**SUBJECT | DEVELOPMENT PERMIT APPLICATION NO. DP1176 –
611 KENNEDY STREET |**

To present for Council’s consideration, a development permit application for a two-storey, multi-family residential building with four dwelling units at 611 Kennedy Street.

1 Site Plan
Scale: 1:200

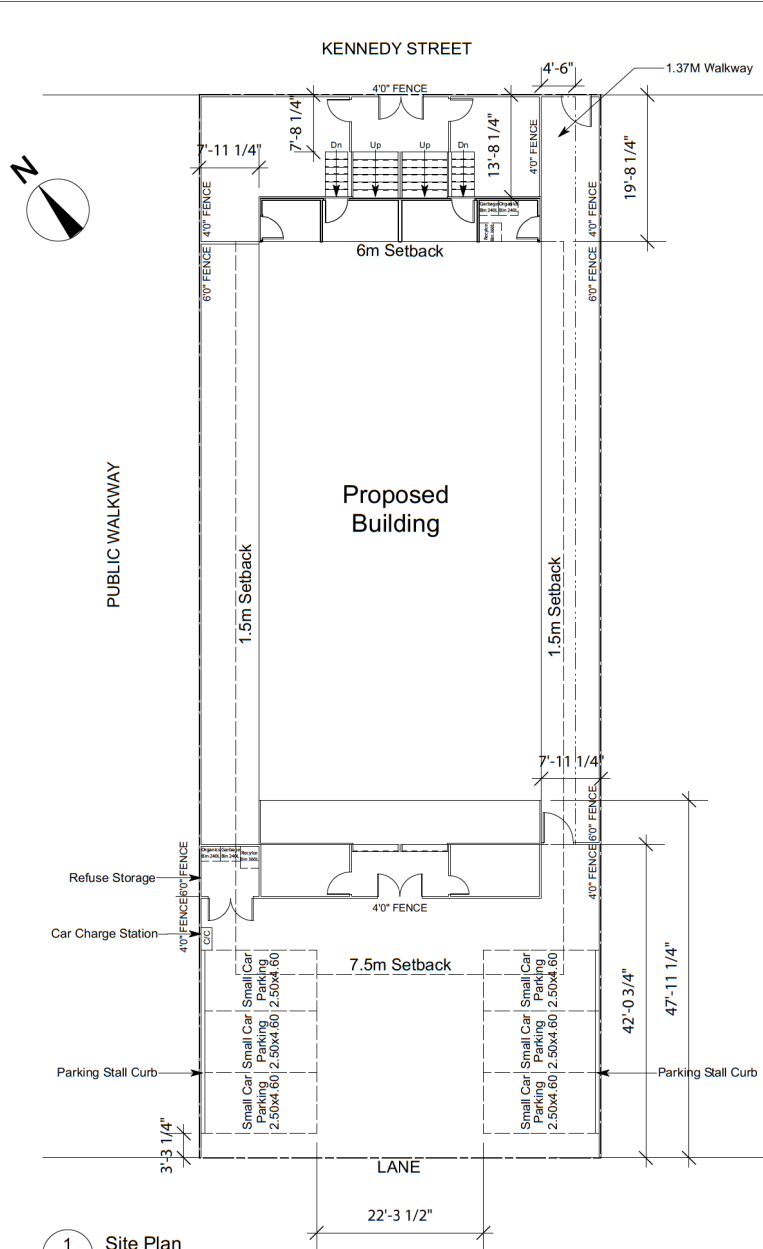
The maximum allowable amount of small-car parking spaces is 40% of the required parking (two spaces). The applicant is proposing 100% of the required parking (six spaces) be small-car parking spaces; a proposed variance of 60% (four spaces).

The width of the subject property does not allow for the minimum required standard vehicle parking stall length in addition to a two-way drive aisle. No negative impact is anticipated. Staff support the requested variance.

1. *Section 4.3 ‘Small Car Spaces’* – to increase the maximum allowable percentage of small car parking spaces from 40% to 100%.

LANDSCAPE PLAN

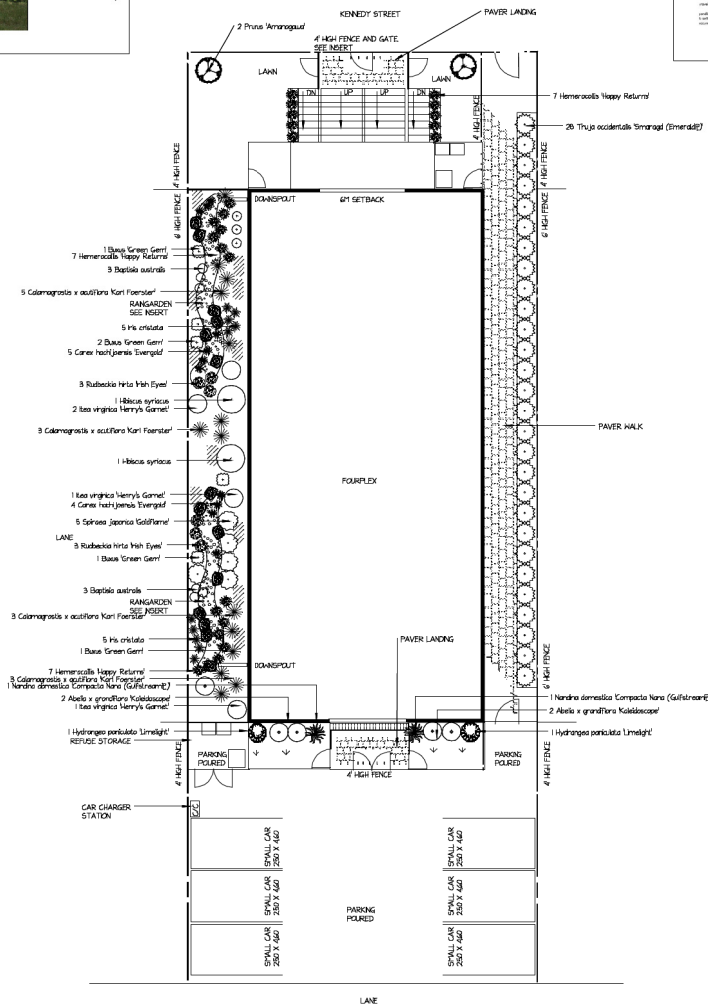
- A more cohesive landscape design that treats the site holistically is needed;
- More plant material including trees is needed. Existing trees should be retained where possible;
- Some landscape buffering should be provided between this development and the neighbour to the east;
- Traditional landscape structures that reiterate the building's craftsman design style could be used, i.e., craftsman-style fences, gates, trellises, etc., which could also incorporate hedges and vines;
- Consider engaging a qualified landscape professional familiar with designing storm water management/landscape features like rain gardens and bioswales; and
- Add windows to the sides of the building.

The applicant incorporated design changes to strengthen the craftsman style, such as adding corbels in all gable ends and mullions in the transoms of the windows. The applicant also resubmitted an improved landscape plan with a rain garden, additional trees, and site lighting in response to Staff comments. The proposal is consistent with the relevant design guidelines and staff recommend approval of the development permit.
